Attn: Kimberly Shields, Grove City Development Department

From: Phil Moorehead, Faris Planning & Design

Re: Application #201506010036 -Village Communities responses to Staff Report dated June 15, 2015 for The Village at Gantz Meadows Final Development Plan application

EXHIBIT B

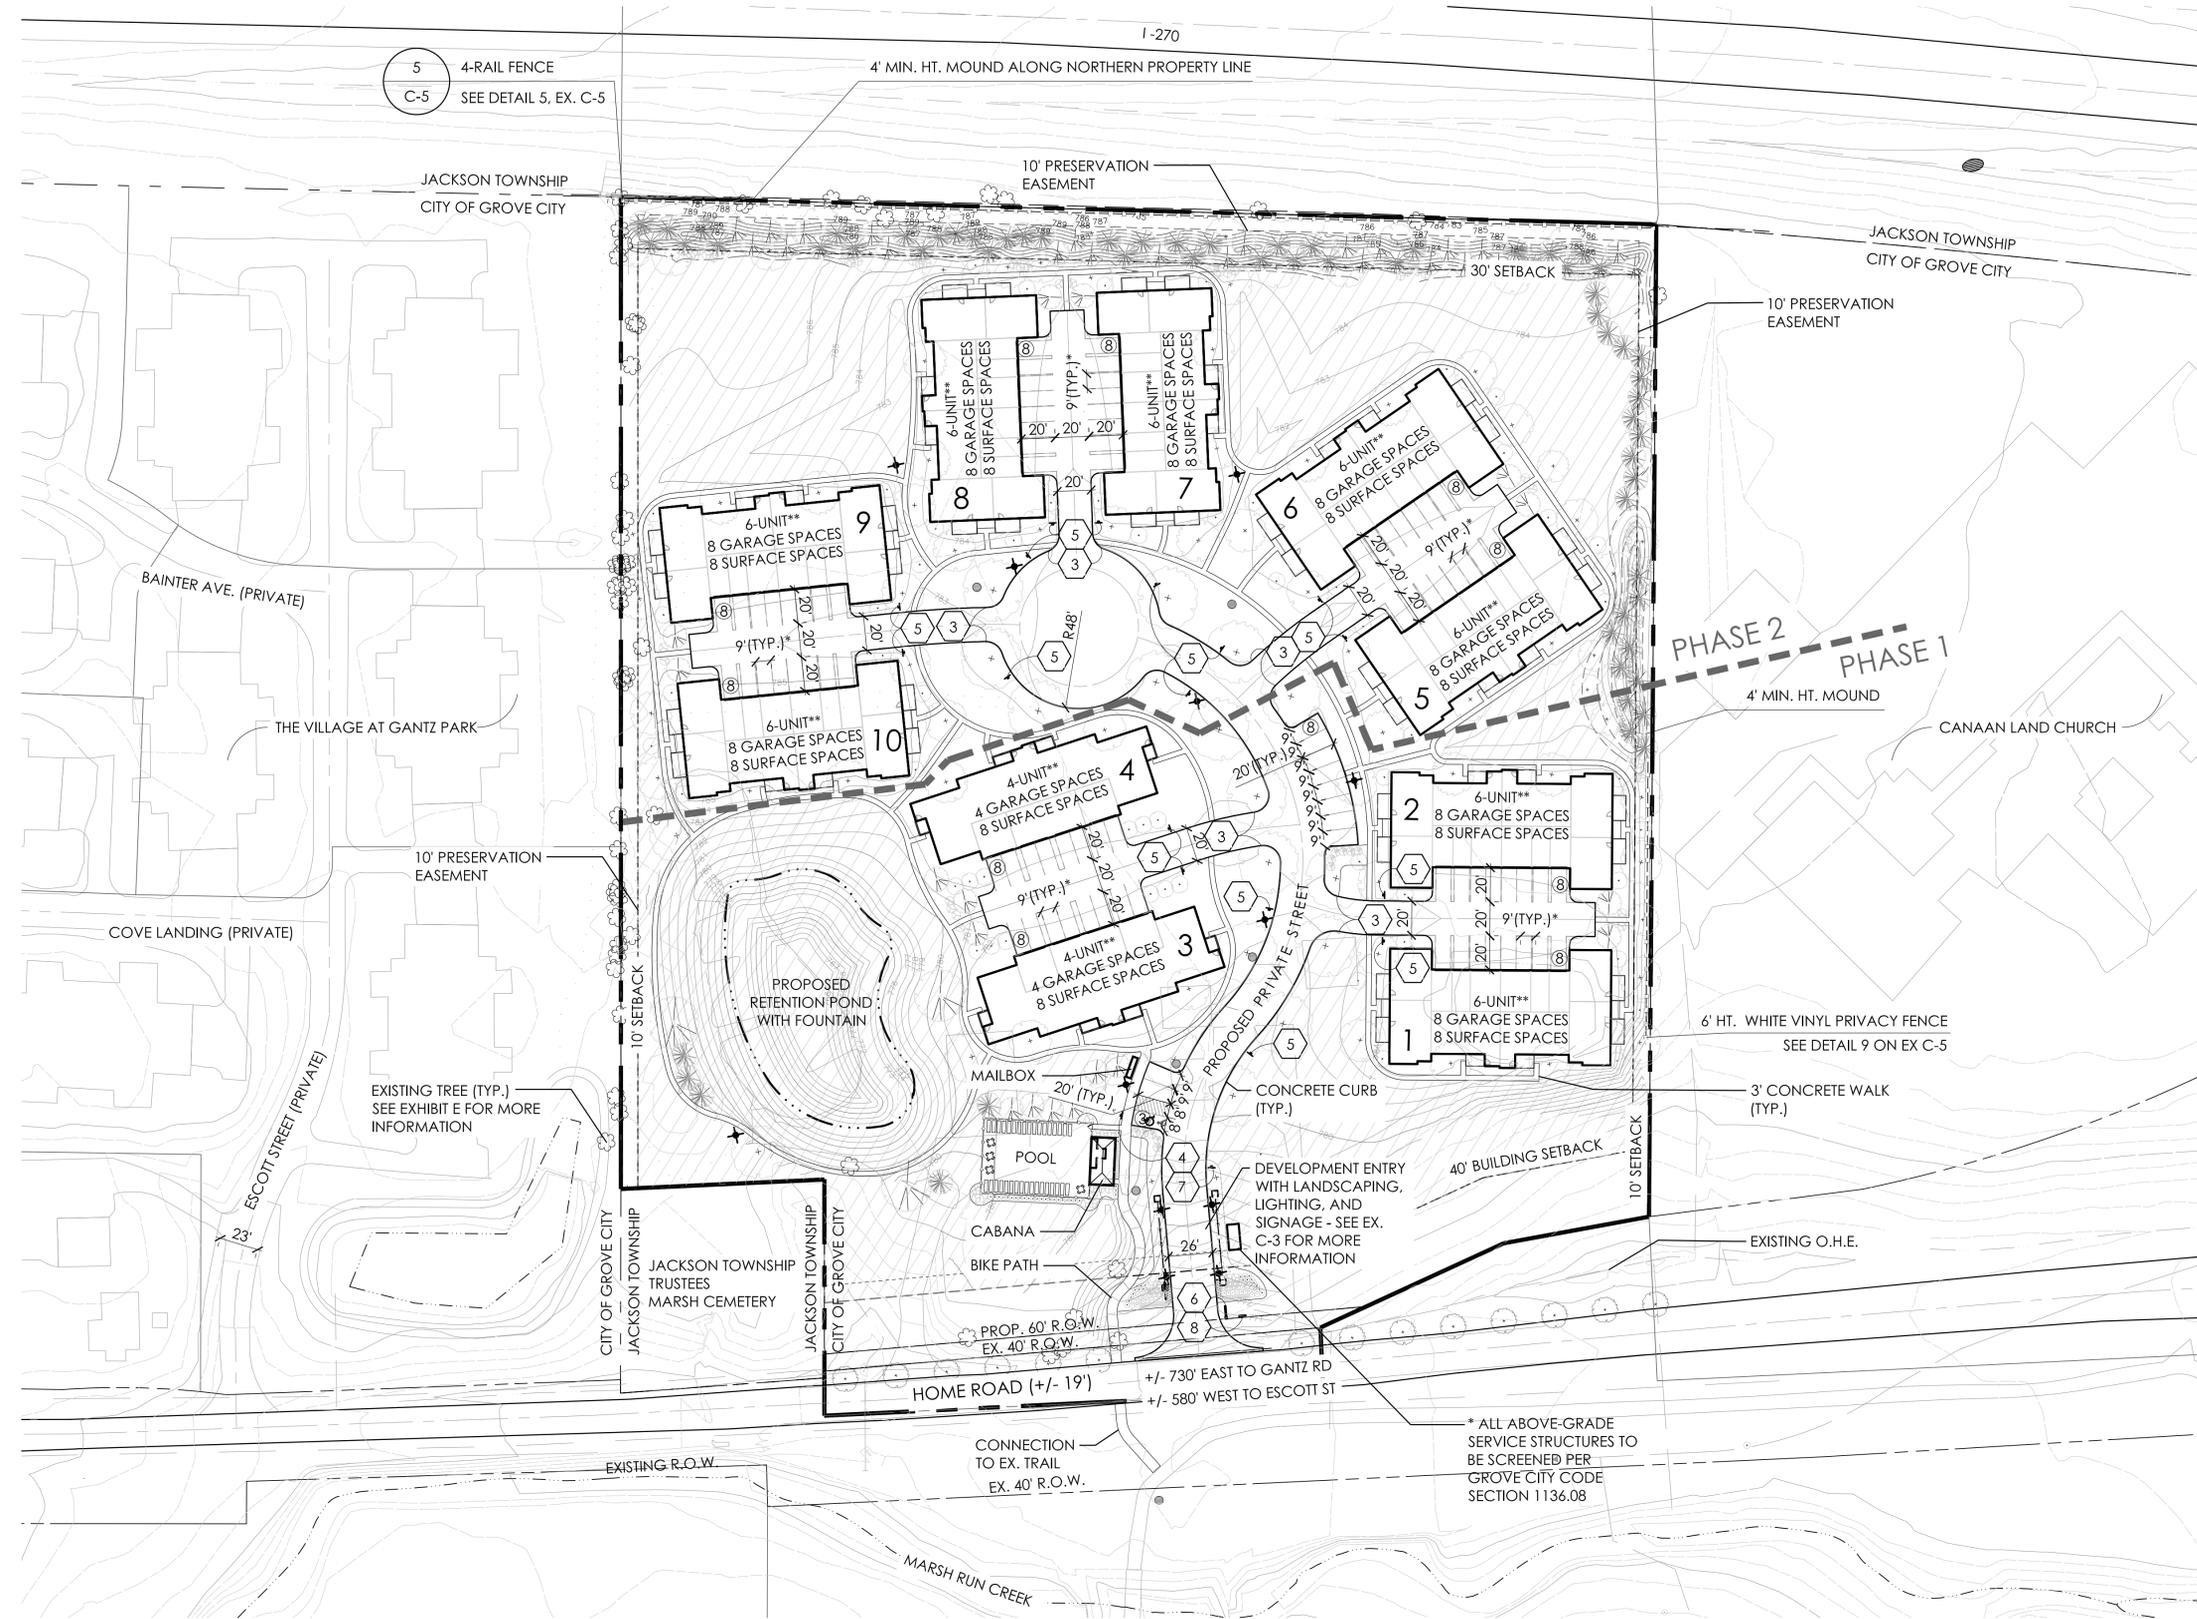
1. Based on the number of dwelling units proposed, 2.5 acres of open space is required in the development, per Section 1101.09 and the zoning text for the development. The 4.28 acres of open space shown on plans was calculated as any space not covered by a building or a road or driveway. Section 1101.09 requires that open space be exclusive of any landscape area without recreational amenities (including buffer landscaping adjacent to roads). Furthermore, stormwater retention areas cannot constitute more than 15% of the open space. The open space total and areas noted on Exhibit B (Final Development Plan) should be adjusted accordingly.

Urban Forestry (Jodee Lowe, 614-277-1103)

RESPONSE: Open space was recalculated and itemized, pond accounts for 9.1% of total.

9 6' HGT. WHITE VINYL PRIVACY FENCE
SCALE: N.T.S.

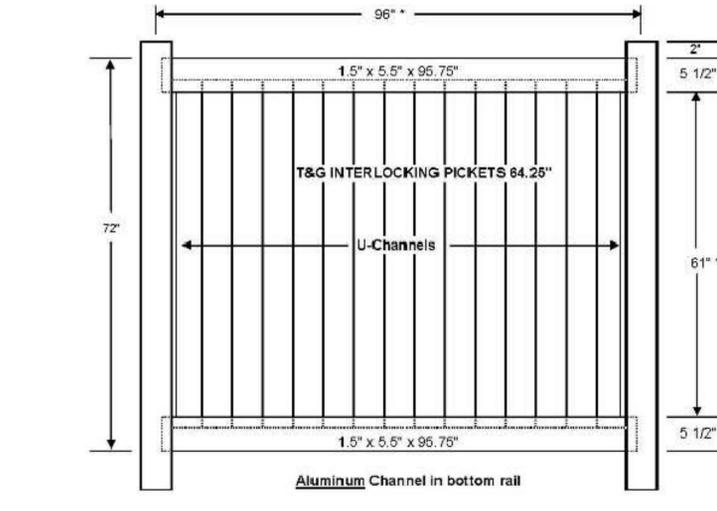
2. Details should be submitted for the proposed 6' vinyl privacy fencing. Fencing should be white to match the three and four rail decorative fencing used elsewhere on the site.

RESPONSE: The 6' White Vinyl Privacy Fence detail was added to Exhibit C-5.

EXHIBIT E

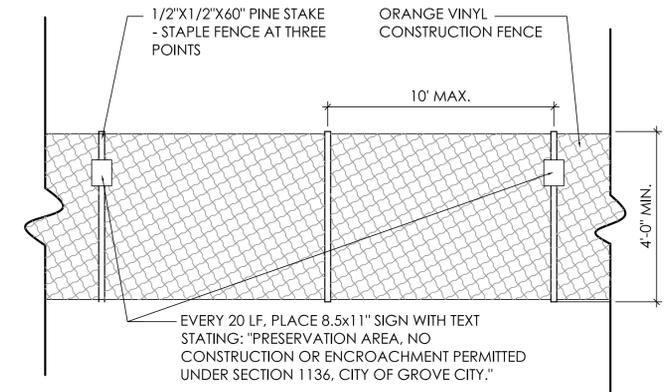
6. 1136.10: Preservation of Existing Streets during Construction-there needs to be a preservation plan for the trees that are to remain during the construction process

RESPONSE: A Tree Preservation Plan was added to show existing trees and trees to remain during construction. Please refer to Exhibit E.

EXHIBIT G-3

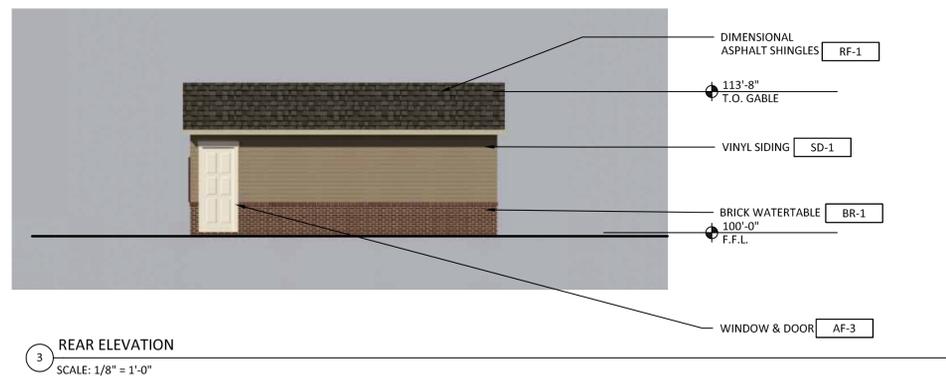
3. Elevations should be submitted for the proposed cabana. The architecture of the cabana should match the character of the primary structures (dimensional shingles, brick or stone, natural earth tones).

RESPONSE: Elevations of the cabana have been included. Please refer to Exhibit G-3.

EXHIBIT G-4

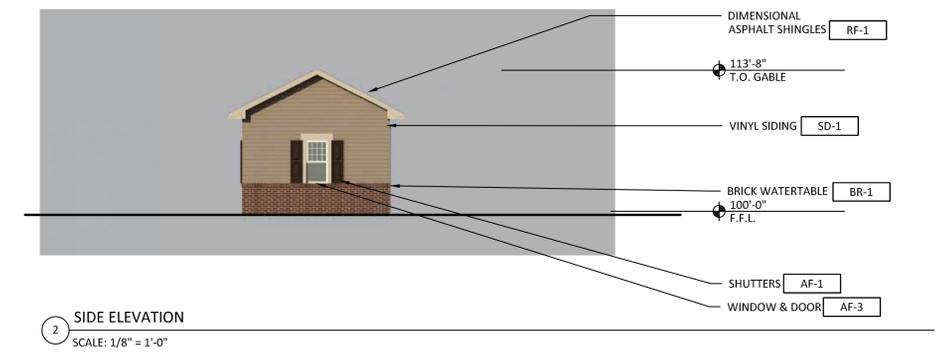
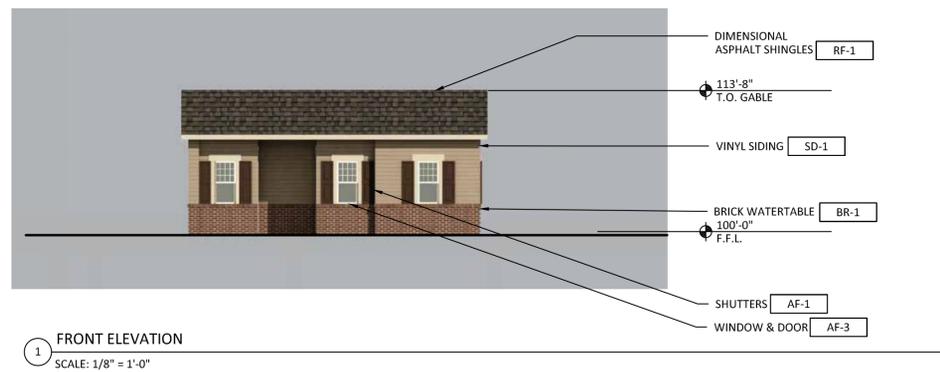
4. An 8.5x11" exterior material detail sheet should be submitted outlining the color and manufacturer of all proposed exterior materials.

RESPONSE: An exterior material detail sheet has been included. Please refer to Exhibit G-4.
